SERVICE LETTER

No. 635

Subject: Avco Lycoming Service Bulletin No. 356, dated September 1, 1972.

SUBJECT: Addition of Alternator Bracket Support

Installation of Alternator Bracket Support

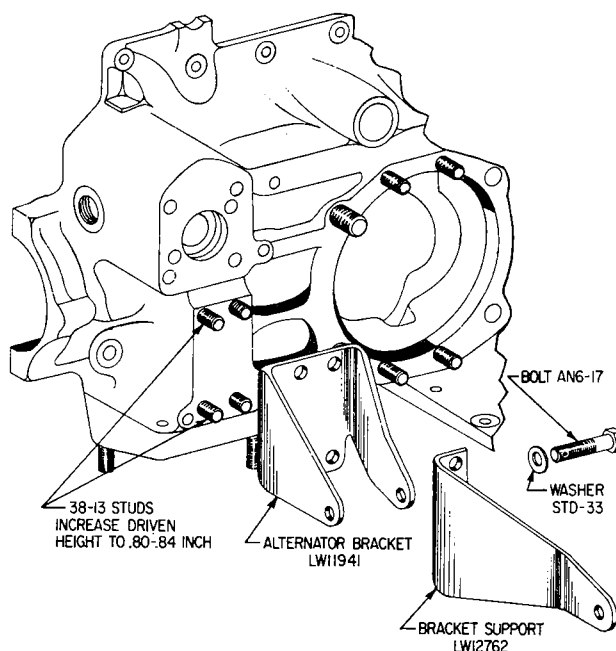
To strengthen the alternator bracket (LW11941) it is recommended that the bracket support (LW12762) be installed as soon as possible. The following changes are necessary when installing the bracket support. The driven height of the two studs, indicated on the accompanying illustration, must be increased from the present height of .74 - .78 inch to .80 - .84 inch. Two nuts may be jammed on the 3/8 studs to turn them outward; turn slightly beyond the specified height and check the torque required to drive them to the correct height. The required torque should not be less than 160 inch pounds; if it is, an oversize stud should be installed.

The bolt indicated on the accompanying illustration must be changed from the present AN6-16 to an AN6-17 bolt and a flat washer (STD-33) installed under the bolt head at assembly.

1. Refer to Avco Lycoming Service Bulletin No. 356 (on reverse side).
2. Prior to installing the alternator bracket support, Avco Lycoming Part No. LW12762, inspect the alternator bracket, Avco Lycoming Part No. LW11941, shown on Avco Lycoming Service Bulletin No. 356 sketch; if evidence of cracks is noted, replace alternator bracket.
